PZ&B Staff Combination Memorandum: Landmarks Preservation Commission and Town Council

SUBJECT: COA-24-0010 (ZON-24-0032) 228 SEASPRAY AVE (COMBO)

MEETING: AUGUST 21, 2024, LPC
SEPTEMBER 11, 2024, TC

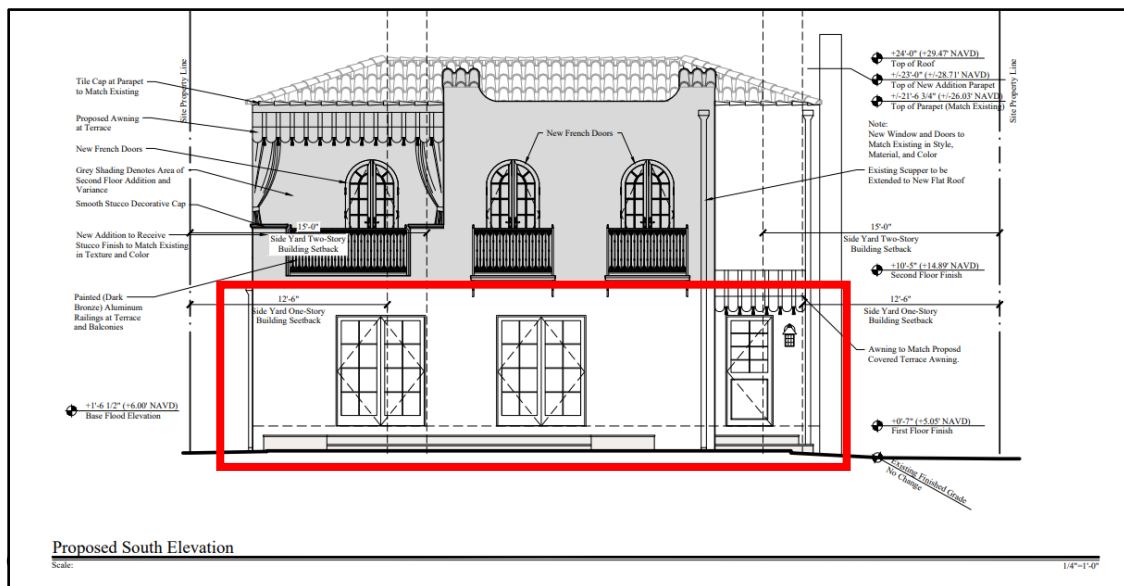
The new second-story addition and covered terrace are proposed on the south (rear) elevation of the structure. Although the residence has two stories, at the rear there is a one-story volume. The new addition and terrace will be located above it. Four windows will be removed on the second floor to accommodate the addition. A flat roof design with a decorative parapet with clay barrel tile caps which is consistent with the architectural style of the residence is proposed. Four (4) sets of arched wood French doors with divided-light patterns are proposed, one (1) them will be added to the existing exterior wall of the structure. A stucco finish will be installed to match existing ones. Two (2) projecting balconies with dark bronze aluminum railings will be located on the south side of the addition.

Directly west of the addition, a new covered terrace will be created. It will include a new awning with a forest green stripped pattern as well as dark bronze aluminum railings and balcony walls.

Overall, the design of the new addition and covered terrace is compatible with the Mediterranean Revival structure. Although a lower parapet height could achieve a greater level of differentiation from the existing structure, the proposed parapet with decorative elements and tile caps also satisfies this historic preservation objective.

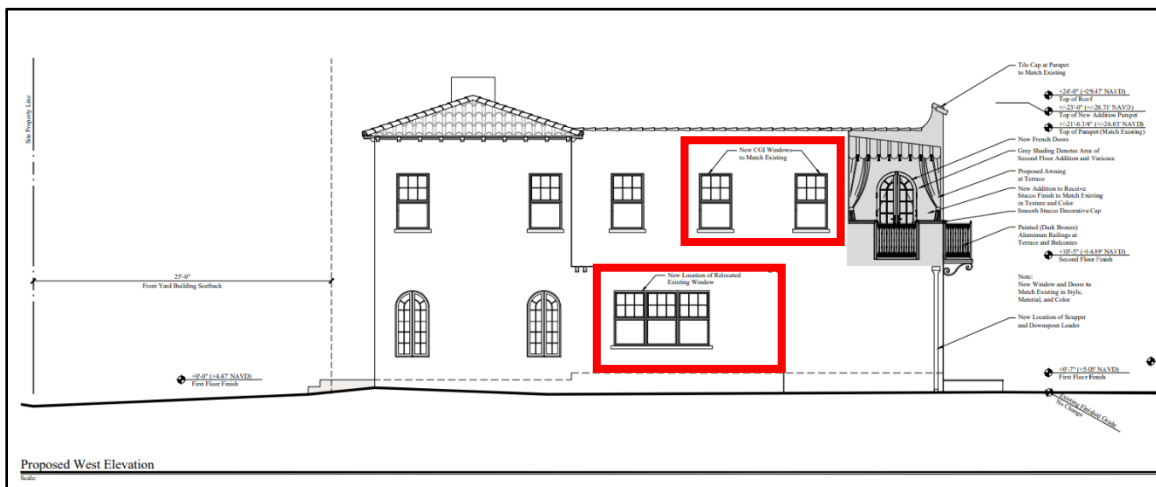
On the first floor of the south (rear) elevation, the existing pergola will be removed. An existing awning will be replaced above a door on the eastern side of the façade. The awning will feature the same design and color scheme as the one proposed on the second-floor covered terrace.

metal sash window and one (1) white metal fixed window (that replicates the appearance of a sash window) with greater spacing between them. One of the removed windows will be reinstalled on the first-floor façade. Additionally, a triple window on the ground floor will shift slightly to the north to accommodate an adjusted floorplan.

From a historic preservation perspective, original openings should remain. However, the proposed changes will be minimally visible from the street. Staff recommends that the Commissioners discuss whether the new windows should be wood frame to match the existing fenestration.
